Application for Licence Amendment

Licence Number	L6248/1991/8
Licence Holder	Water Corporation
File Number	DER2013/001029-1
Premises	<p>Karratha No. 1 Waste Resource Recovery Facility</p> <p>Lot 1933 Millstream Road</p> <p>KARRATHA WA 6714</p> <p>Legal description -</p> <p>Lot 500 on Plan 74743</p> <p>Lot 600 on Plan 74155; and</p> <p>Lot 3921 on Plan 216652</p> <p>Crown Reserve 35053</p> <p>As defined by the Premises maps in Schedule 1 and the coordinates in Schedule 2 of the Revised Licence</p>
Date of Report	01/06/2023
Decision	Revised licence granted

1. Decision summary

Figure 1: Permanent sludge drying beds 1 to 10 to be reconstructed

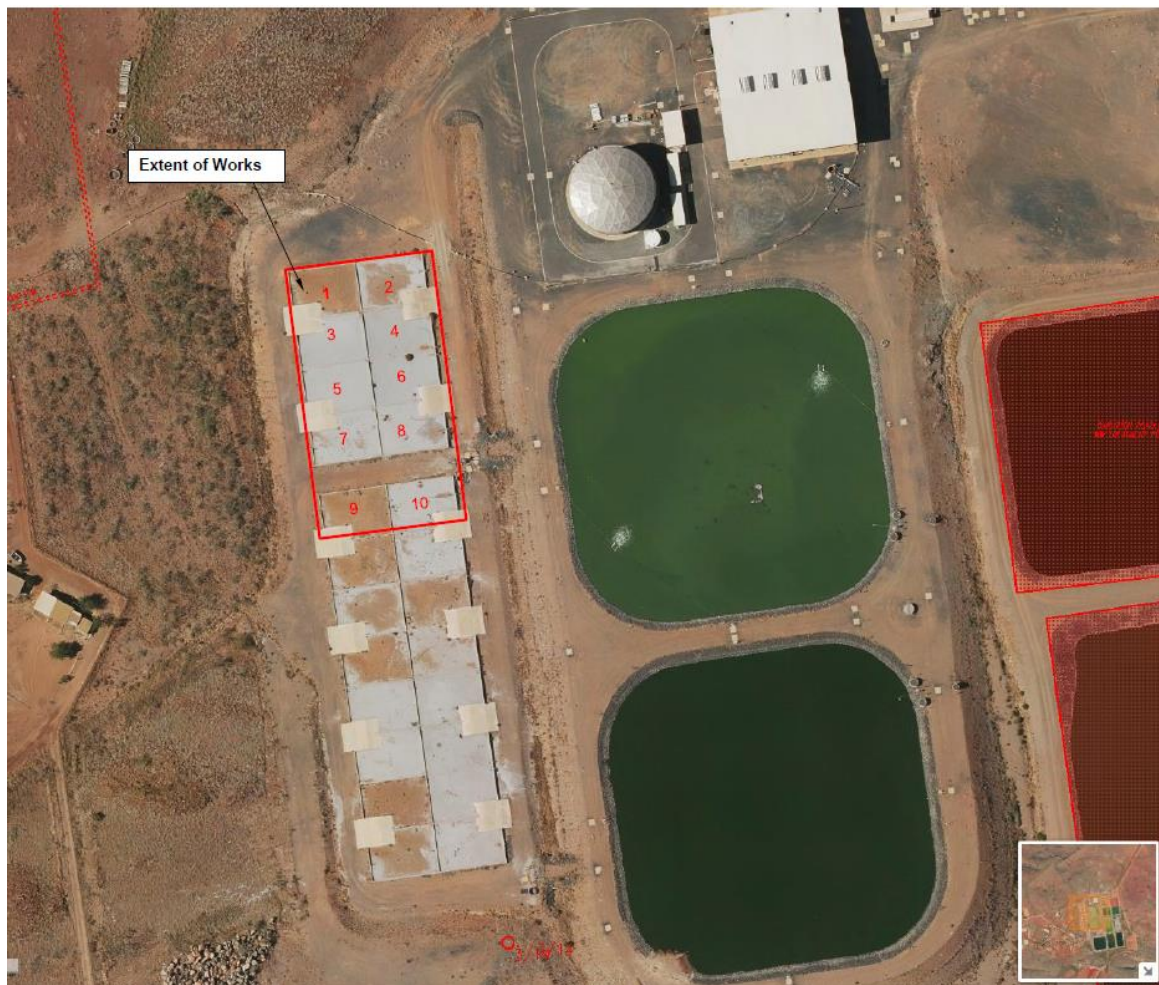
Investigations have found GCL is not a preferred liner option as when it dries out between uses it is easily damaged by media and vehicle traffic. Remedial action is proposed to retain the existing bed structure and reline the floors with concrete. Due to limited funding only 10 beds will be remediated to enable the sludge accumulation for inflows up to 5 ML/day. The Licence Holder intends to repair the drying beds with concrete for its durability in harsh conditions with long wet/dry cycles to meet a permeability of $\leq 2.96 \times 10^{-9}$ m/sec.

The existing walls of the sludge drying beds were deemed to be over-restrained and under-reinforced, therefore, it was considered likely that rigid repairs using injection grouting would not prevent the development of new cracking. Methodologies that allow the walls some movement have been adopted to limit the likelihood of the development of new cracks. A series of repair details have been developed where the largest cracks will be sealed for water retention but enable expansion and contraction to relieve stresses in the structure. A dual layer sealant system will be used to provide added protection.

The slab has been designed in accordance with AS 3735 *Concrete Structures for Retaining Liquid* to support the weight of a nominal 5 tonne vehicle carrying a full load of sludge, in addition to media material loads, thermal and shrinkage effects, where it will be jointless, 40 MPa concrete with dual layers of reinforcement to minimise risk of leakage. The slab levels and falls are based on the existing design and drains have been integrated to replicate the original design intent. The interface with the existing concrete base layer comprises of a retrofitted water stop and sealant layer selected based on operational and environmental factors to mitigate the risk of leakage at the interface to the existing base layer. The detail has been designed to accommodate the maximum expected slab shrinkage, thermal shrinkage, and differential settlement under loading. Joint details inclusive of water stops and sealants have been selected based on operational and environmental factors to mitigate the risk of leakage at the interface to the existing structure.

There are no proposed changes to Category 54 activities from the previously assessed Existing Licence L6248/1991/1, as outlined in Table 1. Figure 1 shows the existing 24 sludge drying beds and the 10 beds that will be remediated.
